# MEMO

**PROJECT NO.:** J000814

**SUBJECT:** PEER REVIEW RESPONSES TO 100 & 110 TE MOANA ROAD, FLOOD ASSESSMENT & STORMWATER MANAGEMENT CONCEPT MEMO

Figure 1 Chillingworth Stop-Bank Breach Scenario Peak Depths

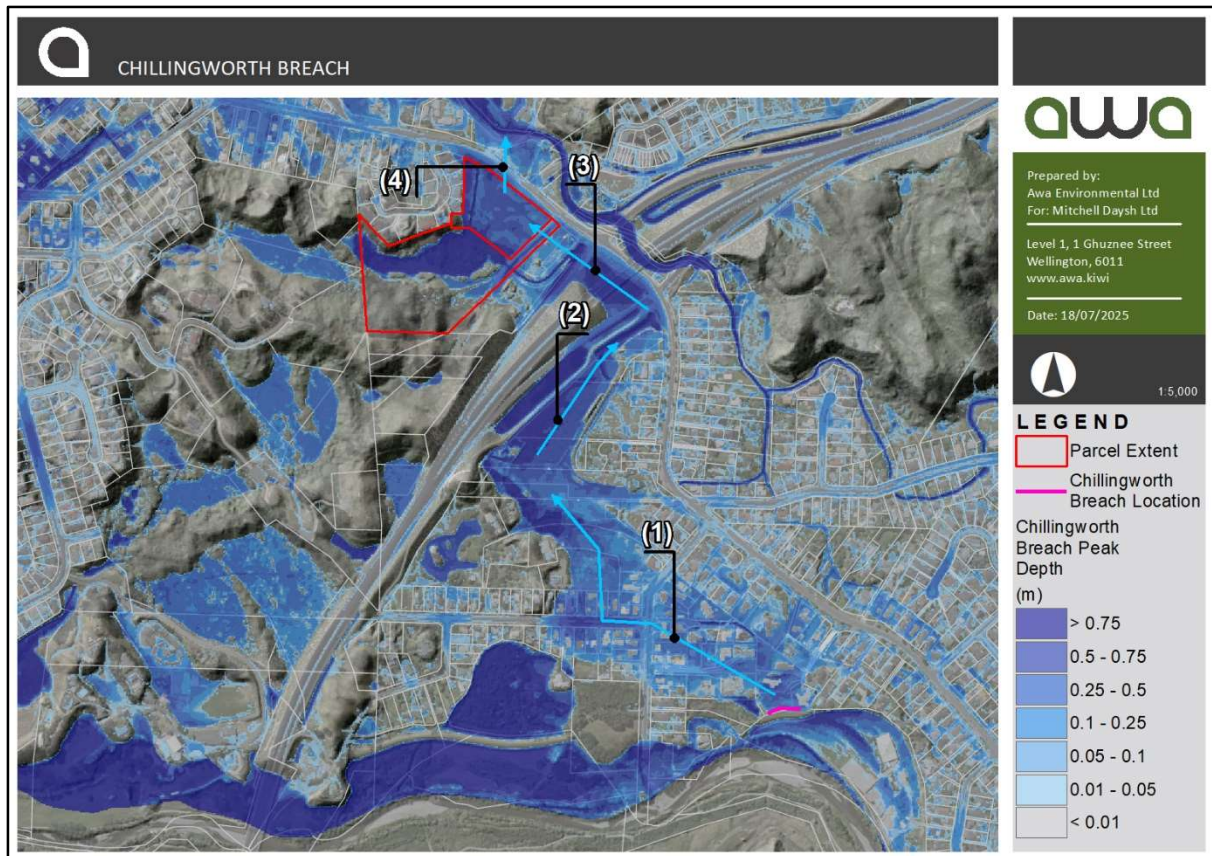
*RFI – Update information provided around the effects of the Chillingworth stop bank breach.*

There are impacts on peak depths within the site associated with the Chillingworth stop-bank breach scenario.

1. Breach flows move north-west toward the expressway following the lowest topography.
2. The low-lying ground adjacent the expressway stores some of the flow moving north.
3. Flow moves under the expressway and into the site.
4. Flow moves over Te Moana Road and into the Waimeha Stream

Peak depths within the site are in the order of 10 mm to 600 mm in this breach scenario.

There is sufficient scope, through site earthworks, to maintain the “effective functionally” of the residual overflow path through the site post development. A specific flood hazard assessment will be undertaken, including the development design, as part of future resource consent applications.

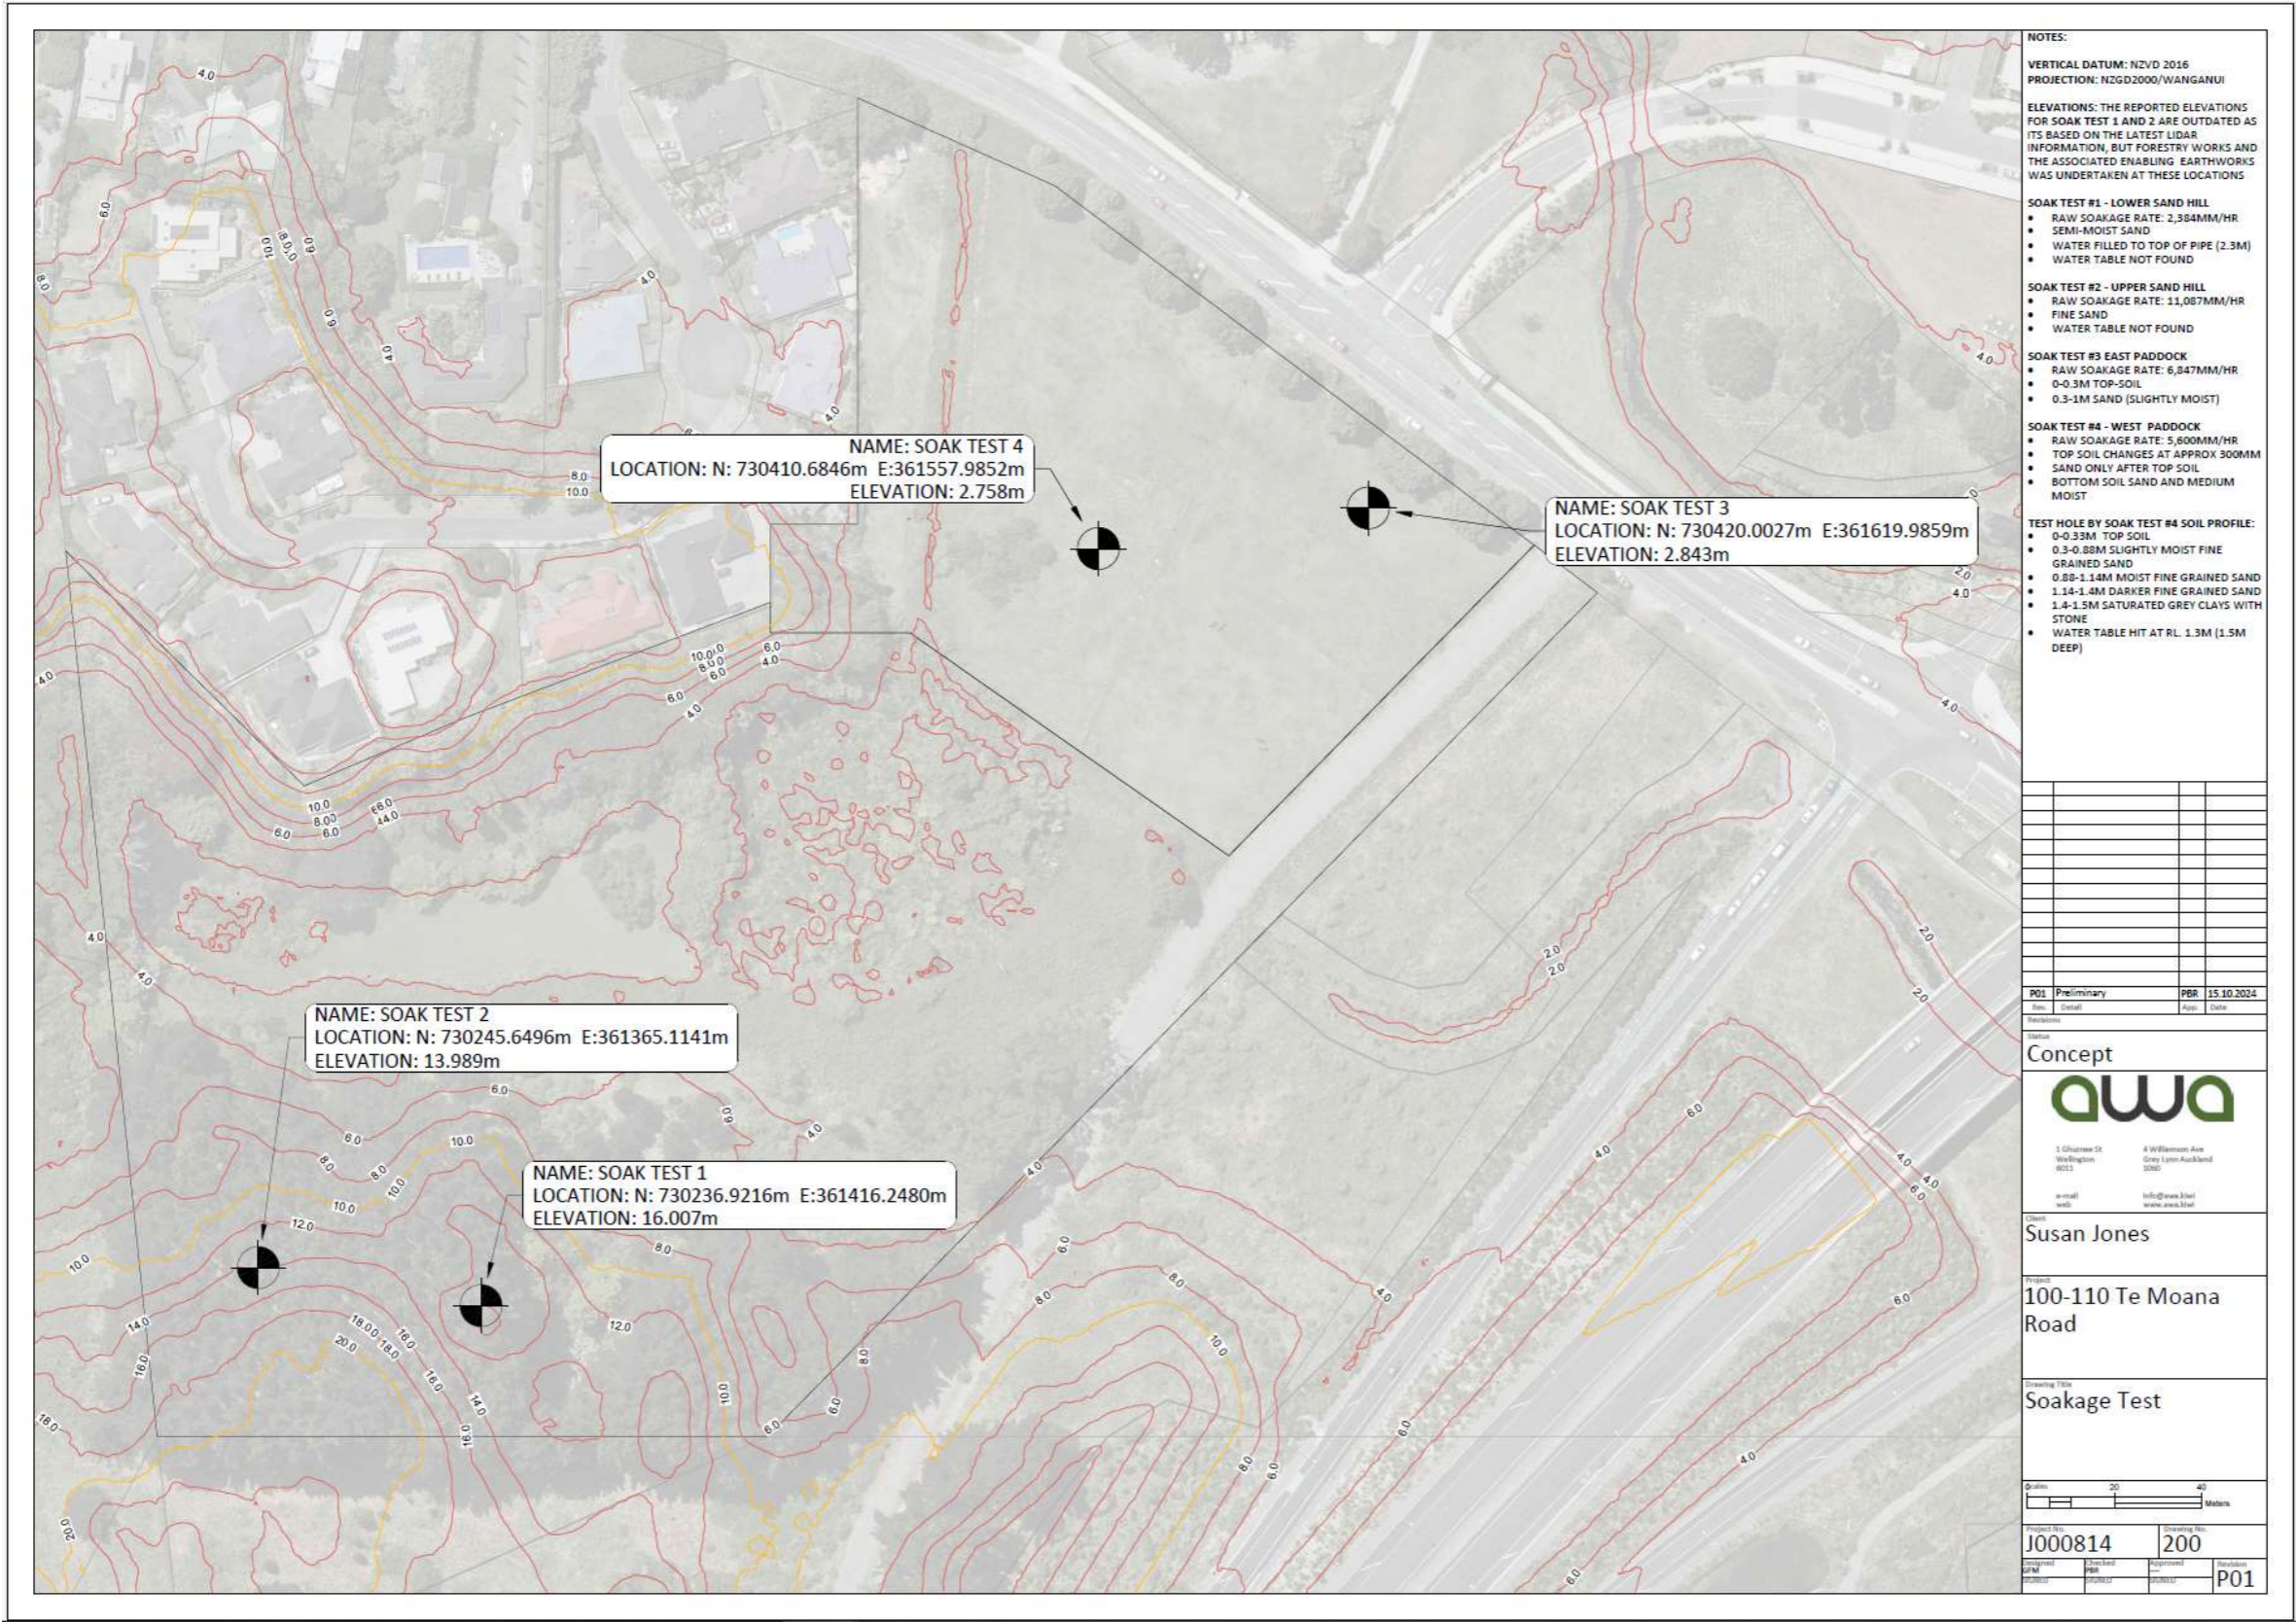
*RFI – Provide a clear solution of how the stormwater associated risks are managed for flood plain filling and peak flow rate mitigation.*

This is a flood assessment & stormwater management concept memo for a plan change application. The purpose of the memo is to provide an overview of the local and regional flood hazard associated within the site and whether there is sufficient scope to mitigate development of the site. A specific flood hazard assessment will be undertaken, including the development design, as part of future resource consent applications.

**Soak test 1**  
**Lower Sand hill**

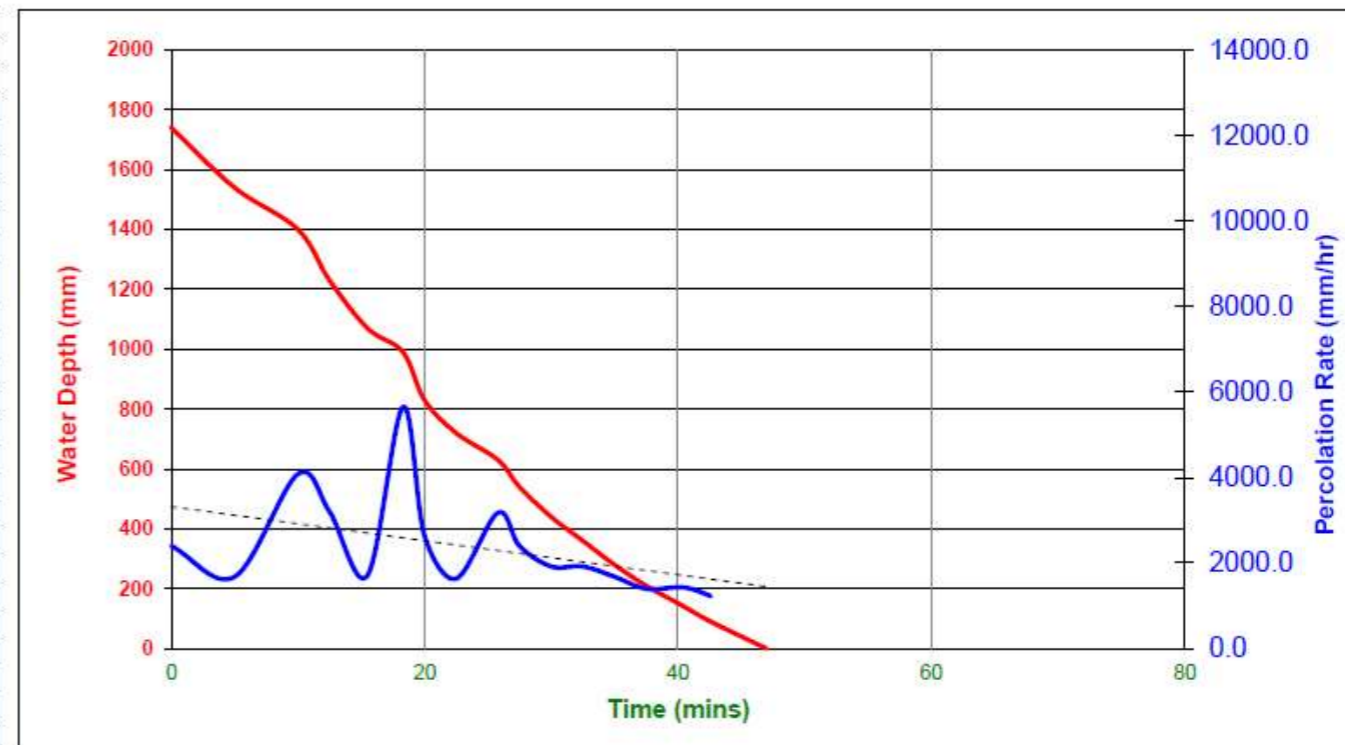
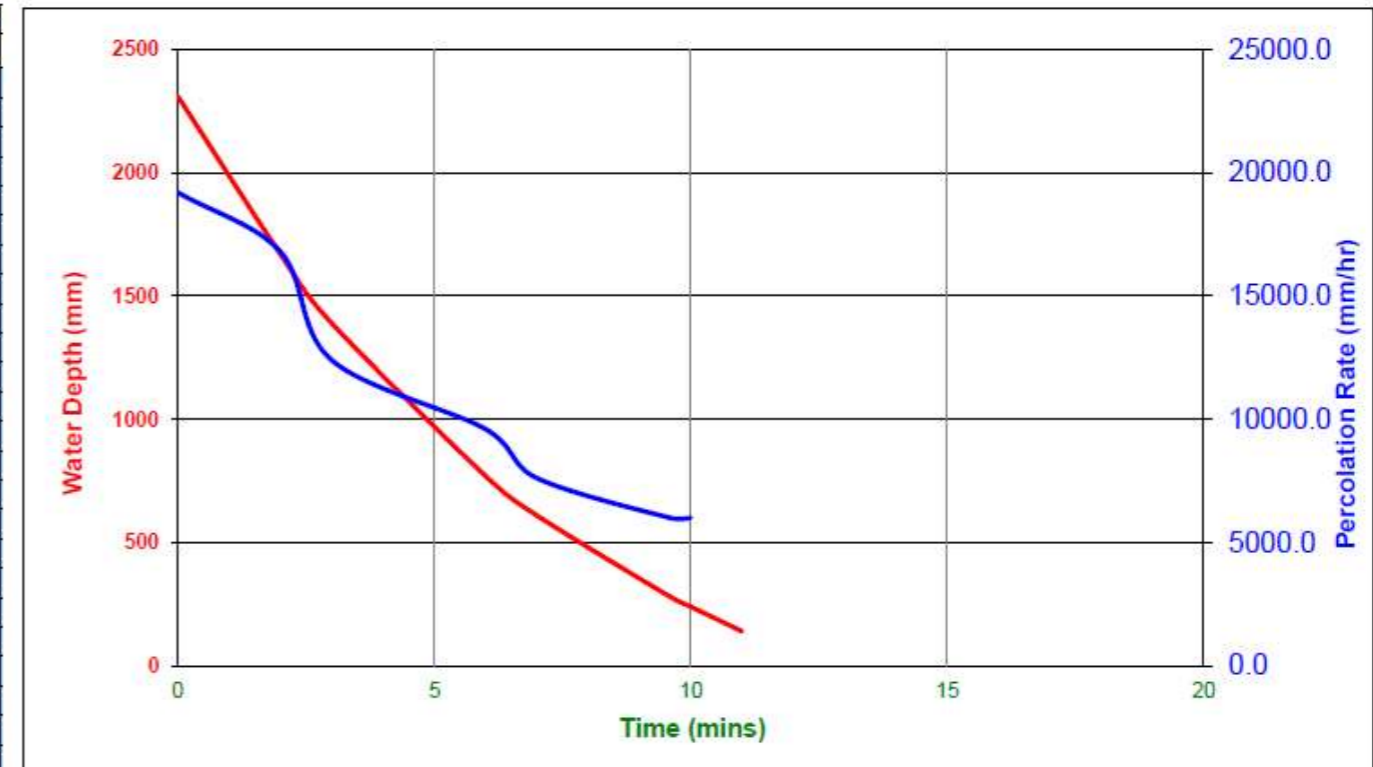
*RFI – Provide detailed soakage test information.*

See detailed soakage test information in Appendix 1.

Pipe Depth (m) = 2.34 m

Average	2384.4	596.0941
Soakage Rate	(mm/hr)	
Soakage Rate	57.23	
per day	(m/day)
